State of Alaska
Department of Fish and Game
Habitat and Restoration Division

Nomination for Waters
Important to Anadromous Fish

Anadromous Water Catalog Number of Waterway 182-70-11400-2010 - 3071

Name of Waterway Seal Creek

Phil,

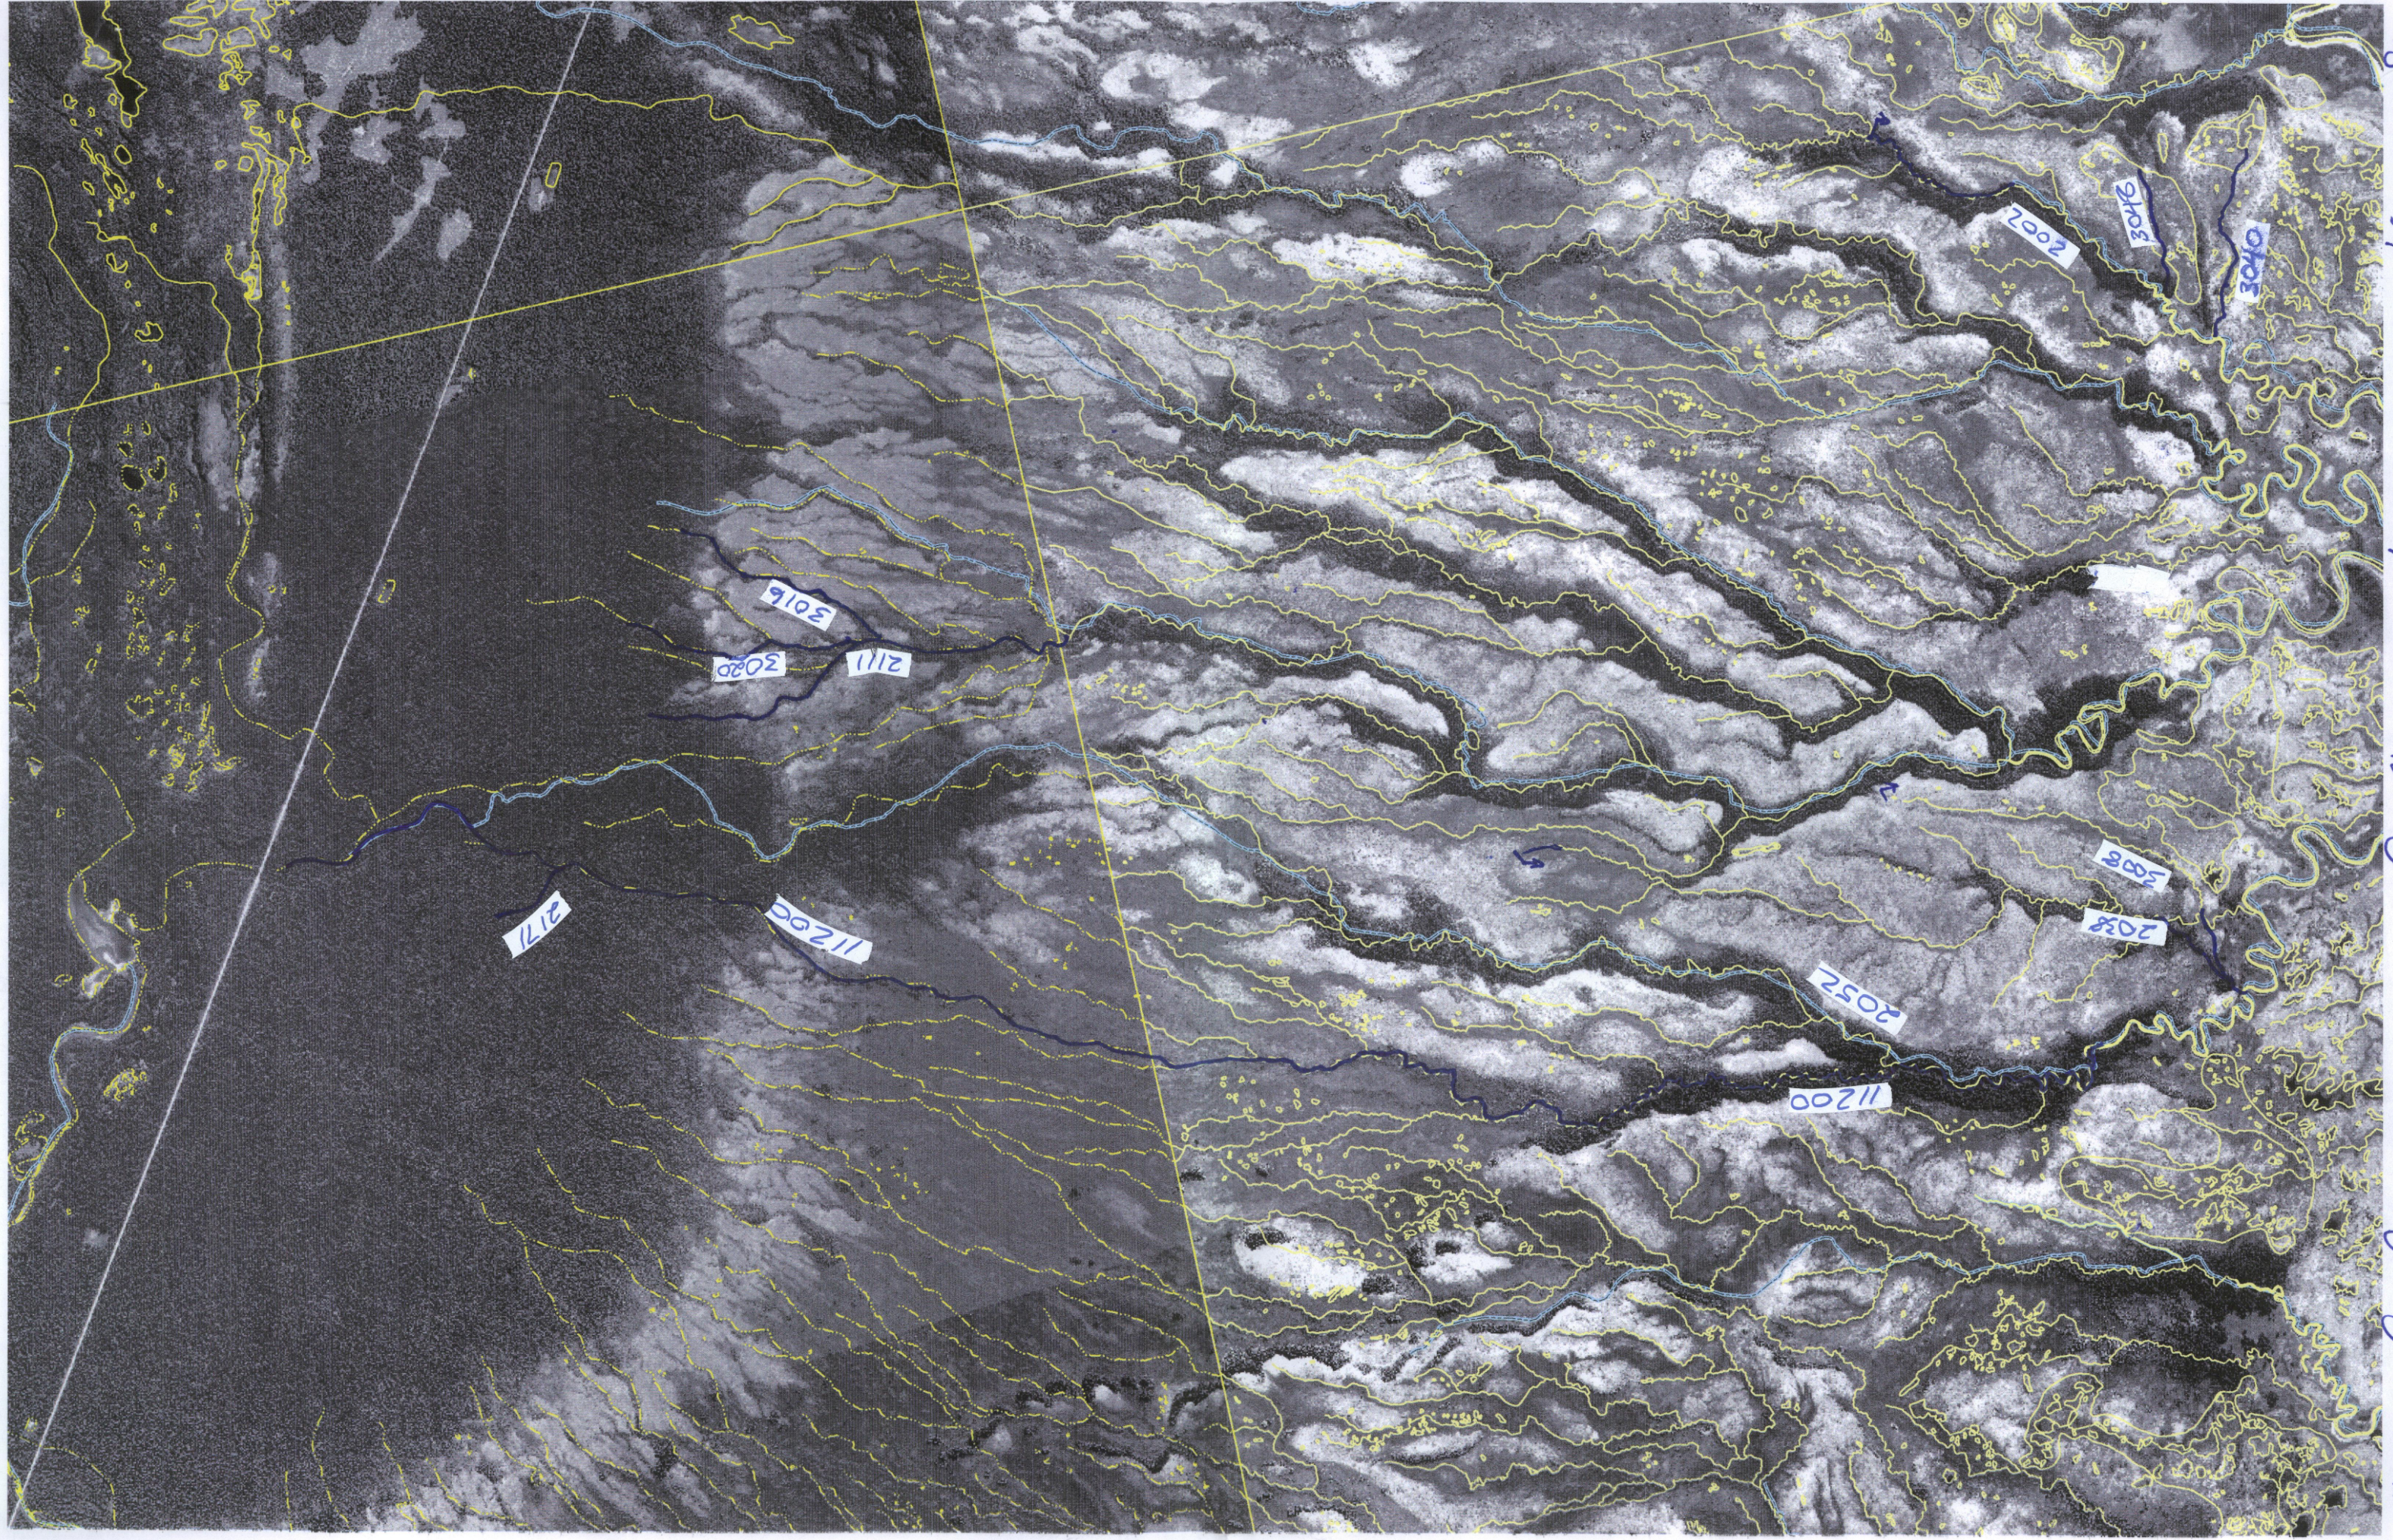
One final question on this. #15 appears to come from and then rejoin stream

2010. Is this the case (a distributary) or is it a separate stream that heads near the 2010 channel?

Looks like a few more of these are jumping between the different hydro streams that I have. Can you look at the attached Jpeg and let me know where the stream should lie for streams 5, 9, 16, 17 and there's also something going on there with the upper section of 2010. I've overlain your original submittal with the hydro and photo in the jpeg.

Nope - I screwed up. It's separate. It come close to but doesn't join up on the other end. In looking at your hydro it is probably the one just to the west. Look at this re-modification jpg and see if that helps. Phil

<< File: SealCrkQ2X.jpg >> Ed - here's the modified jpg for this. This was is pretty tough because of the beaver dam activity throughout this upper area re-routing water every-which-way. My best guess.... Phil

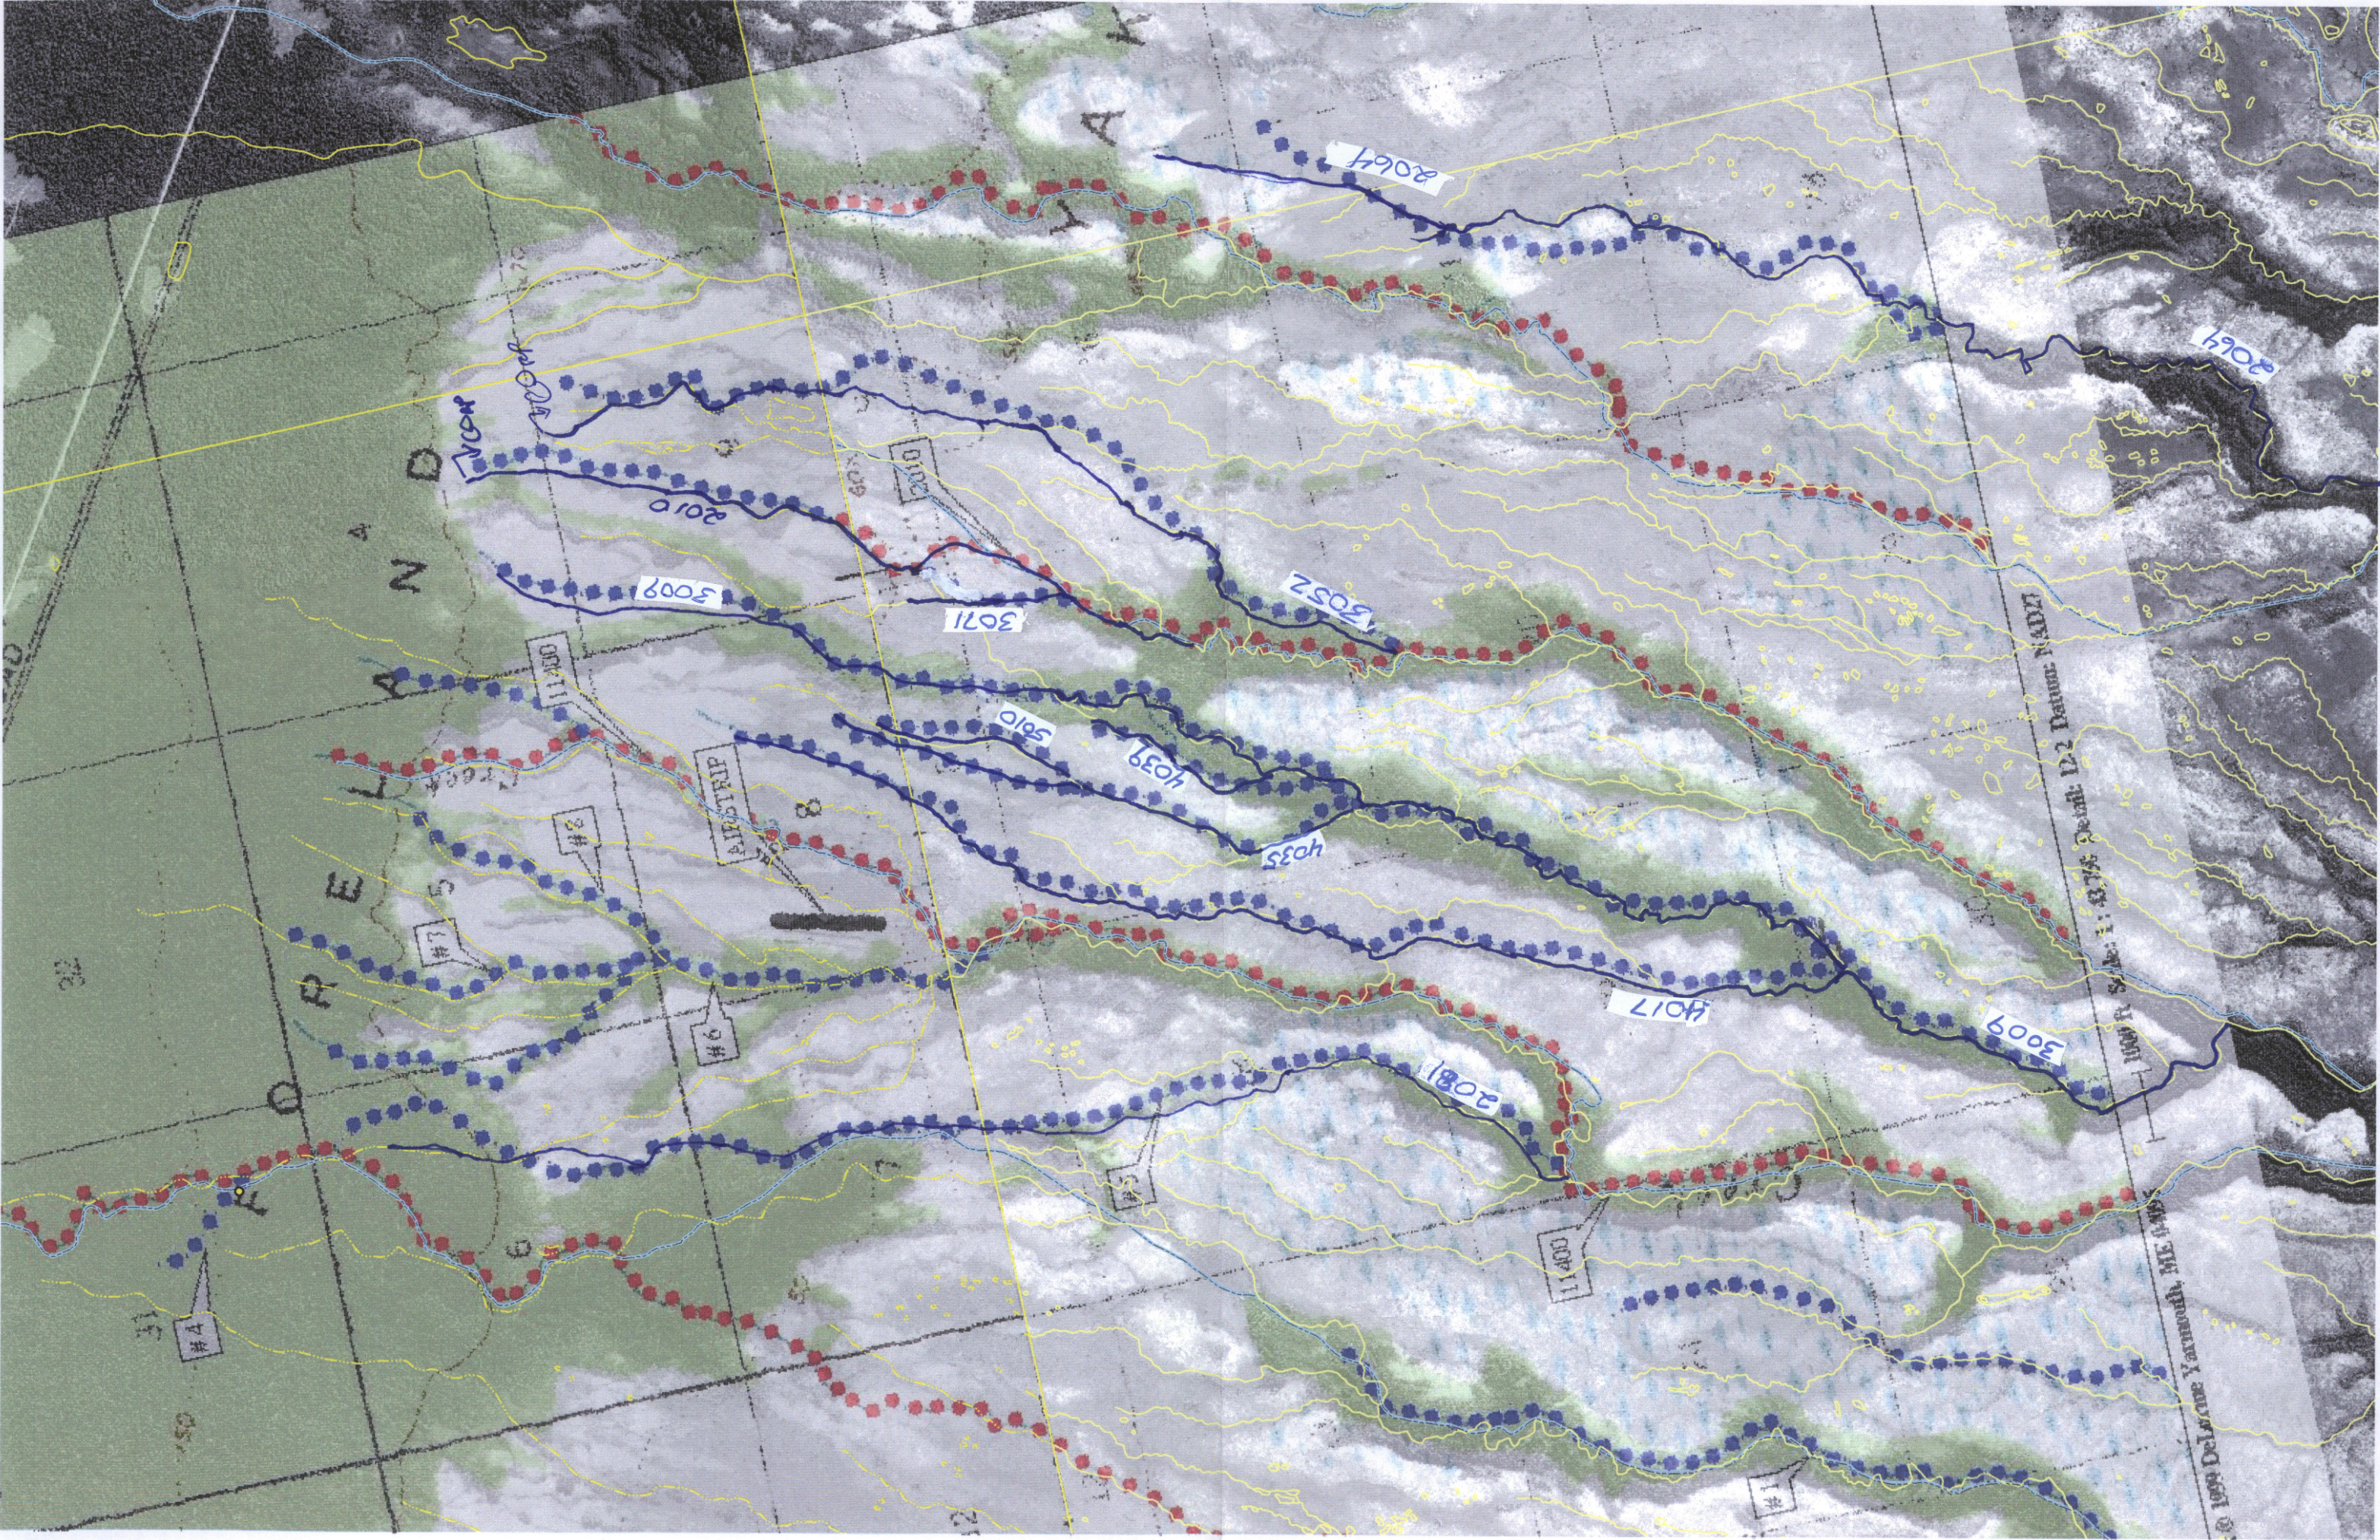
MOVE HYDRO for 11200 as noted. Also note changes to upper & lower ends of 2038
